TRIOMATIC COUPLINGS WITH IMPROVED DESIGN

With a new TrioMatic design we have responded to the stringent requirement of customers to differentiate the WABCO TrioMatic coupling from copy or fake parts.

New WABCO TrioMatic couplings

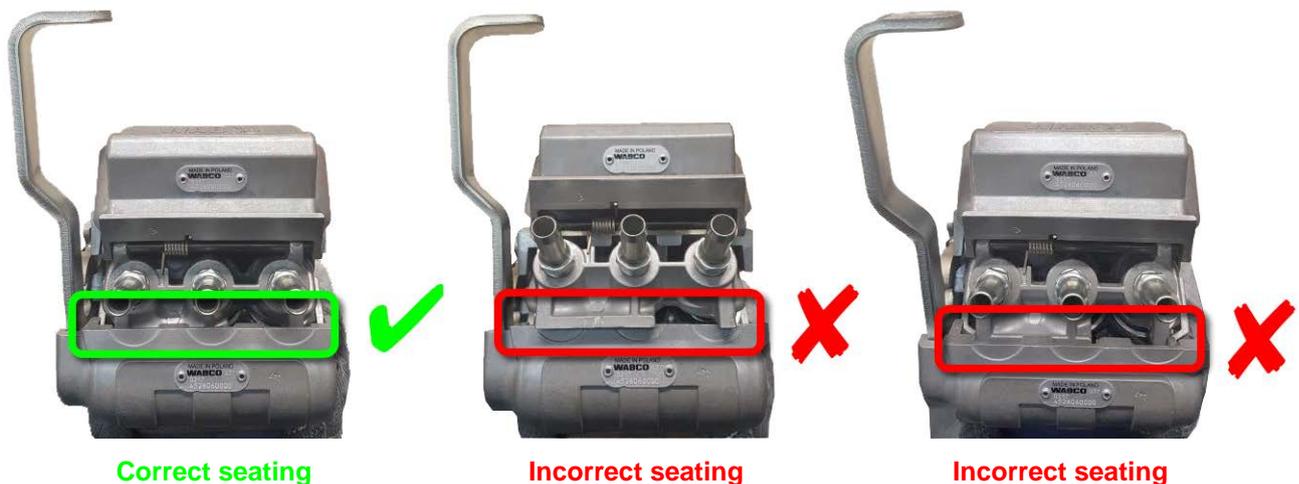
We have improved the design of this safety component by delivering adjustments to the wear-intense areas, casting and overall product appearance.

- Male part coupling forehead is machined to provide better sealing
- Casting type change delivered lighter parts while maintaining corrosion resistance and tightened tolerances
- Part appearance has been improved by introduction of the WABCO corporate design

Due to the design improvements you may encounter difficulties with interchangeability of the new improved male part and the old female part. This can easily be overcome by positioning accurately the male part into the female connector.
